Mr. Steve Kennealy
Director, Manufactured Buildings Program
The Commonwealth of Massachusetts
Department of Public Safety
Board of Building Regulations and Standards

Re: 500 Sq. Ft. Draftstop Proposal – Comments and Cost Estimate

DETAIL #2
FLOOR/CEILING DETAIL
WITH DRAFTSTOP JOIST

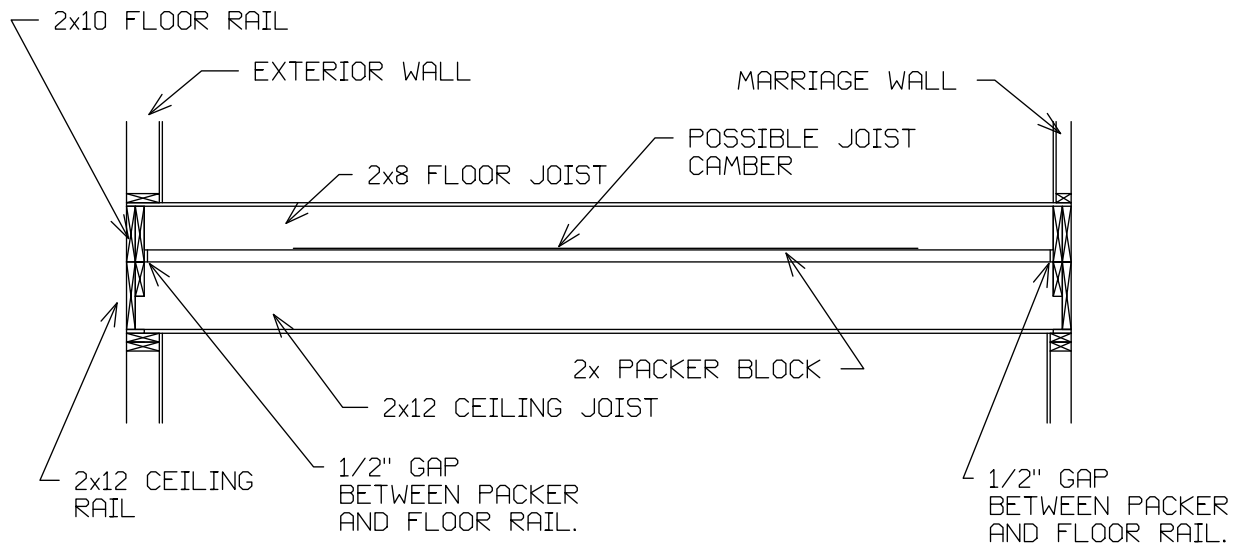
1. The attached drawing (M-101), Detail "A" shows our method of constructing a typical floor/ceiling assembly for a 2-story house. Detail "B" shows how we would create a draftstop within the floor/ceiling assembly. Due to our floor joist being one joist-depth less than the rim joists (i.e. 2x10 rims = 2x8 floor joists), we must install a 2x packing member on top of the 2x12 ceiling joist to fill the void. This packing member would not be cut to "exact" size as it could bind and conflict with the floor rim joists of the module being set on top of it in the "setting" stage of construction.

2. Due to the gap presented at the ends of the packing on top of the 2x12 ceiling joist (described above), and the possibility of floor joist camber creating additional gap along the joist length, we would not install the ceiling gypsum in the ceiling cavity adjacent to the draftstop joist to allow the Builder to effectively caulk all gaps at the end of the packing and any gaps along the length of the draftstop joist "after" the module above is set into place.
